SERVICE LETTER NO. 74-5

DATE: MAY 9, 1974

SUBJECTS: ITEM 1. CANOPY LOCK SEALING
 ITEM 2. FUEL TANK ACCESS COVER IMPROVEMENT
 ITEM 3. CARBURETOR AIRBOX BEARING REPLACEMENT
 ITEM 4. WIRE BUNDLE PROTECTION

FIGURE 1. CANOPY LOCK SEALING

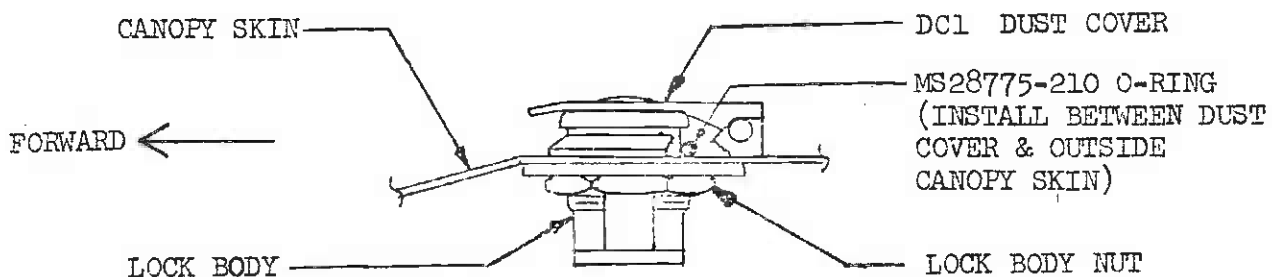
Since the issuance of Service Letter No. 72-3 (ITEM 4. Canopy Latch and Lock Sealing Improvements), dated August 7, 1972, an improved lock dust cover and associated o-ring have been incorporated. The installation of one or both items, as indicated below, will prevent water seepage through and around the lock.

Aircraft serials AA5-0001 through AA5-0440 require the installation of both items: Dust Cover, part number DC1; and O-Ring, part number MS28775-210. Aircraft serials AA5-0441 through AA5-0539 require the O-Ring only, part number MS28775-210.

Installation of the Dust Cover and/or the O-Ring necessitates removal of the outside canopy handle, Royalite trim panels surrounding the canopy latch box and the screws and rivets that attach the latch box assembly to the canopy. By pulling the latch box assembly out of the canopy, access to the lock body nut may be gained. After removing the nut and lock body, discard the existing dust cover and seal, install the improved dust cover and/or O-Ring and reassemble. Four (4) Rivets, part number 1604-0412, are required to reassemble the latch box assembly to the canopy.

See Figure 1 for dust cover and o-ring location.
